**WATTS BAR NUCLEAR PLANT (WBN) UNIT 1 - RESPONSE TO REQUEST FOR
ADDITIONAL INFORMATION REGARDING GENERIC LETTER 2004-02, "POTENTIAL
IMPACT OF DEBRIS BLOCKAGE DURING DESIGN BASIS ACCIDENTS AT
PRESSURIZED-WATER REACTORS" (TAC NO. MC4730)**

**RESPONSE TO 12/5/2008 REQUEST FOR ADDITIONAL INFORMATION REGARDING GENERIC
LETTER 2004-02**

WATTS BAR NUCLEAR PLANT UNIT 1
RESPONSE TO 12/05/2008 REQUEST FOR ADDITIONAL INFORMATION
REGARDING GENERIC LETTER (GL) 2004-02

Figure 2

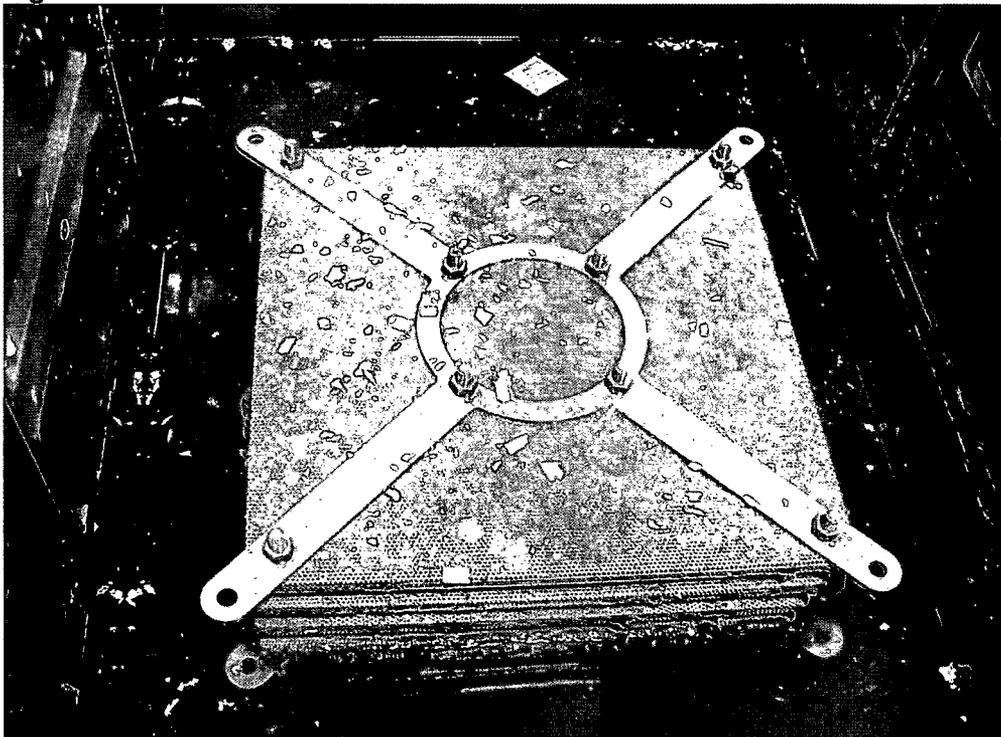
- 3. Please provide a technically defensible head loss evaluation for the strainer that is based on NRC-accepted testing or analysis techniques. The licensee should reference the staff's Watts Bar 1 audit report (ADAMS Accession No. ML062120461) for specific issues with Watts Bar 1 head loss testing. Further, the licensee should reference the staff's review guidance for head loss and vortexing (ADAMS Accession No. ML080230038) for acceptable testing procedures.***

The fibers were mixed in water separately using a mixing device. Following reflective metal insulation (RMI) debris introduction into the test flume, the pre-mixed fibrous debris was added into the test flume. Manual mixing of the test flume was performed before the recirculation pump was started.

Following completion of Test 2, with the pump continuing to run, additional latent fiber was added in the vicinity of the strainer. The additional latent fiber was hand-separated shreds that were subsequently mechanically stirred and mixed with water prior to introduction into the flume. It is conservative to assume that the hand-separated fiber would behave similarly to the blender-processed NUKON. Blender-processed NUKON is generated by stirring shredded NUKON using a kitchen blender to separate the fibers and prevent clumping per NUREG/CR-6885. Thus, since the shredded NUKON was hand-separated into individual fibers and then stirred with a mechanical mixer, the number of individual fibers would be sufficiently fine to represent transport of the individual fibers in the test flume. The additional fiber was introduced within a one foot radius of the strainer to ensure that 100% of the fiber transported to the strainer. Figure 2 shows that the additional fiber which primarily accumulated on top of the strainer, there is still free screen area - demonstrating that a fiber layer that is capable of efficiently filtering particulate would not accumulate on the strainer. The flow rate was increased approximately 2 times that of the designed flow rate and the resulted head loss was still insignificantly low (0.27 ft). Figure 3 below is a photograph taken after completion of Test 2. The photograph shows that even with the additional fiber and the increased flow rate, free screen area exists on the WBN test strainer indicating WBN strainer surface area is large enough to accommodate the additional fiber and increased flow rate.
